550 Epsom Road

Lot 2, 448-550 Epsom Road, Flemington VIC 3031 / PACE / 1159

MINISTERIAL PLANNING REFERRAL

Figure 14: Increased viewcone with columns

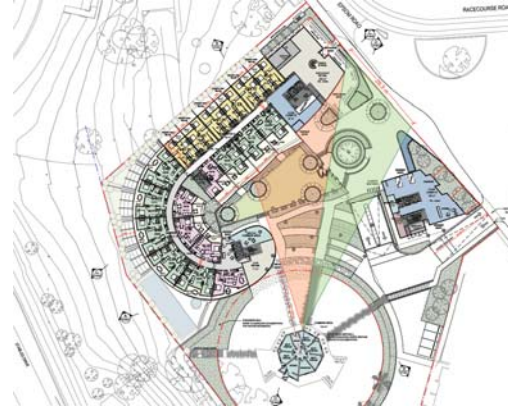
Urban Design has recommended that the columns located within the archway are removed or rationalised to provide unobstructed views to the Jockey's Lodge from Epsom Road. The columns are shown at Figure 12.

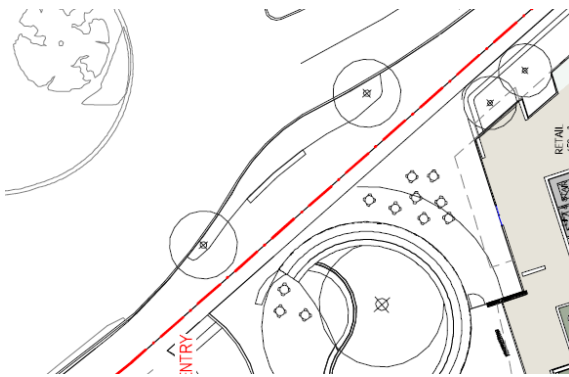
Please also refer to the previous comments copied below. The amendment has not addressed public realm improvements and as such the recommended condition is still applicable.

The opportunity to create space for public tree planting (shown above) is welcomed. It is preferable that tree plots are formed by a continuous soil trench to ensure the largest possible soil volume. Details should be provided on engineering drawings for council approval.

Engineering drawings for public realm works on Epsom Road must show a continuous soil trench of at least 1m and incorporate structural soil to City Of Melbourne specification.

Public realm works outside the title boundaries does not form part of this planning application. Notwithstanding, the above comments could be included as notes on any permit granted.

Figure 15: 24/7 publicly accessible area (shown in green)

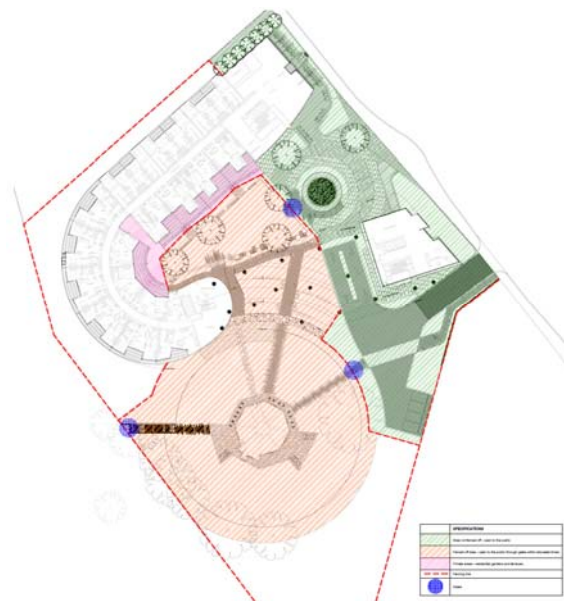
Our preference for the proposed unfenced publicly accessible open space is to have 24 hour public access guaranteed through an appropriate agreement. Please refer to the green area in the provided Landscape Accessibility Plan prepared by Jack Merlo Design and Landscape.

The outdoor area is encumbered. As such, this area is not considered a Public Open Space Contribution, pursuant to Clause 53.01 (Public Open Space Contribution and Subdivision) of the Melbourne Planning Scheme – agreed by the permit applicant. A Section 173 Agreement could secure 24 hour public access in accordance with Figure 15 – **refer recommended Condition 21.**
